UNITED STATES PATENT AND TRADEMARK OFFICE

APPLICATION NO.	FILING DATE	FIRST NAMED INVENTOR	ATTORNEY DOCKET NO.	CONFIRMATION NO.
10/606,479	06/26/2003	Robert J. Smith JR.	16930-1	5653

Office Action Summary

DETAILED ACTION***Response to Amendment***

Marked up Fig.1

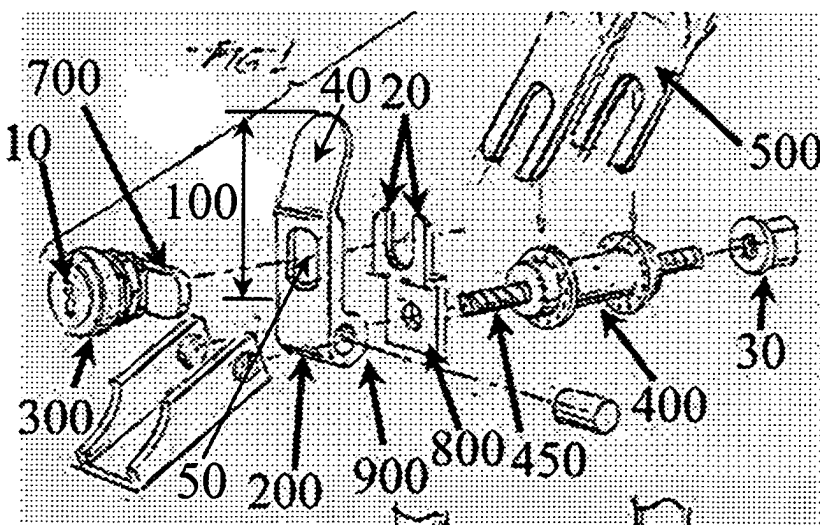
Claims 1-6, 8-13, 15, 18, 19 and 21-23 are rejected under 35 U.S.C. 103(a) as being unpatentable over Katsouros U.S. Pub.20020026816 (see marked-up figures below) in view of Chang U.S. Patent 5479836.

Claim 1. Katsouros discloses a locking quick release device for lockingly affixing a removable component (500) to a fixed component (100, 200 and 400 are fixed to wheel 600), the fixed component having a first member (100, 200) and a second member (400) moveable toward and away from each other between a first position (as seen in fig.2) in which the removable component is affixed to the fixed component and a second position (seen in fig.3) in which the removable component is removable from the fixed component, said locking quick release device comprising: a lever (100, 200) having a handle end (100) and a pivot end (200), the lever being movable about the pivot end between an open position and a closed position so that movement of the lever to the closed position causes the members to move to the first position and movement of the lever to the open position causes the members to move to the second position; and a locking mechanism (300) operatively combined with the handle end of the lever to selectively prevent movement of the lever about its pivot end when the locking mechanism is actuated into a locked position. Katsouros discloses that the removable component is a set of bicycle forks (500). Katsouros does not disclose a seat post. Chang teaches (figs. 3-5, 8 and col.1-4) a removable component that is a bicycle seat assembly (B), and that a locking quick release device is attached to the bicycle seat assembly, for the purpose of securing a bicycle seat assembly against theft. Therefore, it would have been obvious to one with ordinary skill in the art at the time the invention was made to modify Katsouros to be used on a bicycle seat assembly, for the purpose of securing a bicycle seat assembly against theft.

Claim 2. Katsouros as modified by Chang suggests that locking mechanism has a latching mechanism (700); and a receiving member (800) is combined with the fixed component for receiving the latching mechanism to provide for locking of the lever to the fixed component and

Claim 3. Katsouros discloses that the receiving member is combined (in that 800 is attached to 100, 200) with the lever.

Claim 6. Katsouros discloses wherein the lever further comprises a cam surface (900) near the lever pivot end so that movement of the lever to the closed position moves the first and second members to the first position in which they are closer together, and movement of the lever to the open position moves the first and second members to the second position in which they are farther apart.

Claim 8. Katsouros discloses that the locking mechanism has a first end (near 700) and a second end (near 10) with a key slot (10) at the second end, said key slot being adapted to receive a key.

Claim 10. Katsouros discloses that the receiving member comprises a catch mechanism (20) that prevents the lever from moving to the open position when the latching mechanism is engaged in its second position and the lever is in the closed position.

Claim 11. Katsouros discloses that the catch mechanism is comprised of locking pins (elements 200 comprise locking pins within the broadest reasonable interpretation of the claim language).

Claim 12. Katsouros discloses a bore (receiving 450) through both the first and the second members; and a threaded member (450) having a first end (right end of 450) and a second end (left end of 450) with threads on the first end, said threaded member second end combined with the lever near the lever pivot end, said threaded member passing through the bore with said threaded member first end being threaded into one of the members so that rotation of the lever causes the threaded member to move the first and second members closer together and farther apart.

Claim 13. Katsouros discloses a bore (where 200 and 400 receive 450) through both the first and the second members; an opening (50) in one of the members; a threaded member (450) having a first end (right end of 450) and a second end (left end of 450) with threads on the first end, said threaded member second end combined (at 200) with the lever near the lever pivot end, said threaded member passing through the bore; and a thumb screw (30) threaded onto the threaded member first end so that a portion of the thumb screw extends (30 extends from right side of opening in 400) from the opening in the member, said thumb screw capable of moving the first and second members closer together and farther apart when the thumb screw is moved relative to the threaded member.

The applicant argues that the prior art does not disclose the claim 1 limitation “a locking mechanism operatively combined with the handle end of the lever...”. This is not persuasive. Katsouros discloses (as seen in the marked-up figures above) a locking mechanism (300) **operatively combined** (in that 300 and 100 are parts of a common assembly) with the handle end (100) of the lever (100, 200) (emphasis added). The applicant should note the following:

claims. Furthermore, the limitation "extend from an opening" does not require "being inside of the opening". Katsouros meets this limitation since (30) is adjacent to and extends from the right side of the opening in (400).
